ALERT SERVICE BULLETIN

NO. 212-09-131

SUBJECT: INSPECTION/CHANGE OF RESTRAINT SYSTEM ASSEMBLY WITH INERTIA REEL AND MANUAL LOCK HANDLE

SERVICE BULLETIN NUMBER 501836-25-01 ISSUE 1

Figure 1 – Serial Number and Date Code Information

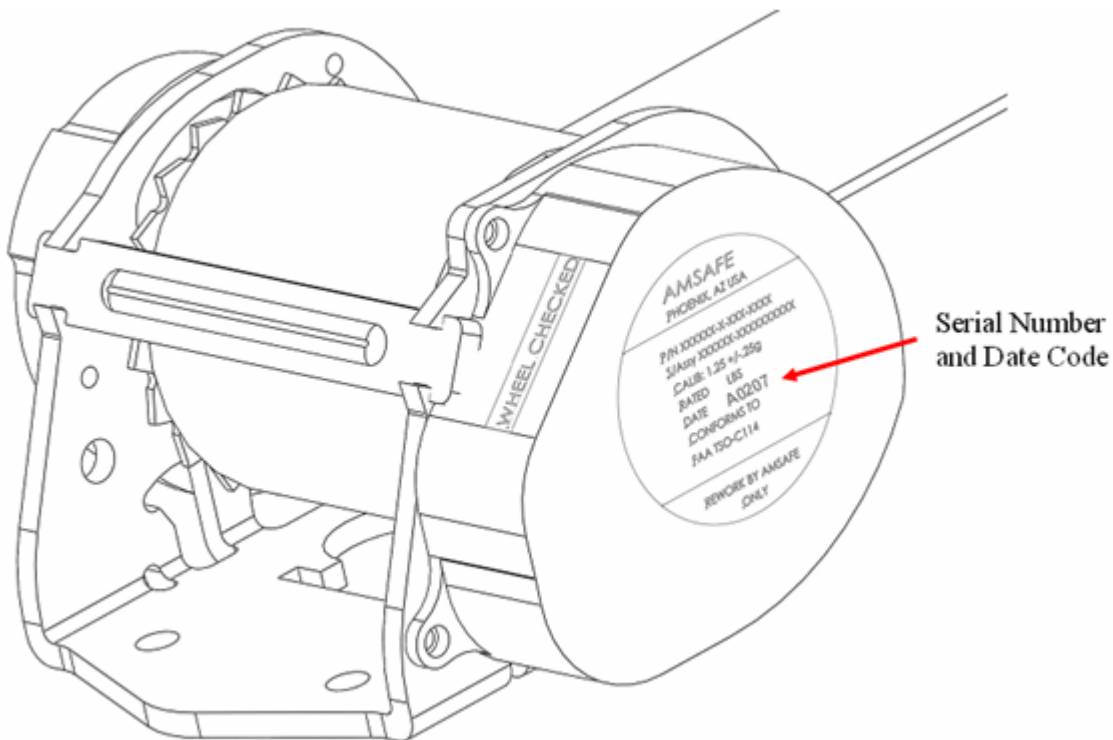
1. The inspection of the restraint system does not require the restraint system to be removed from the seat.
2. Date Code Inspection. The date code can be found on the inertia reel identification label see Figure 1. For access to the inertia reel identification label please refer to the applicable seat manufactures instruction defined in their CMM.

If the date code is prior to 1 Feb 07 (X0207) or after 30 Nov 08 (X1108) no further action is required.

Figure 2 – Wheel Checked Label

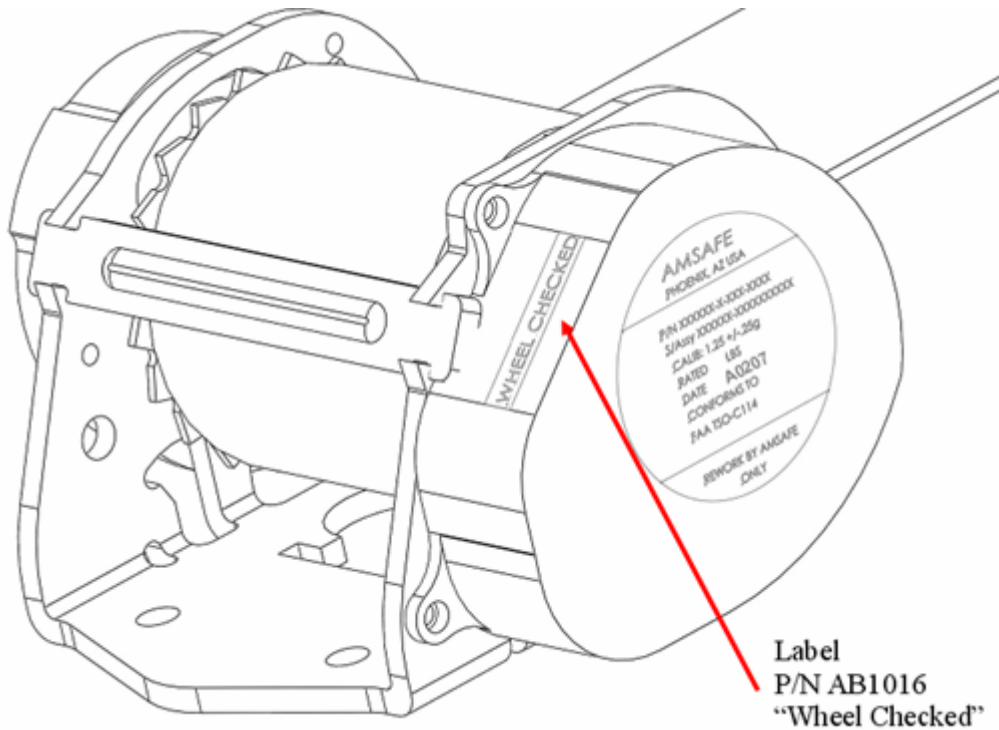
If the serial number is between 1 Feb 07 (X0207) and 30 Nov 08 (X1108), and the inertia reel does not include a label attached by AmSafe stating "Wheel Checked" (Figure 2) continue to step 3.
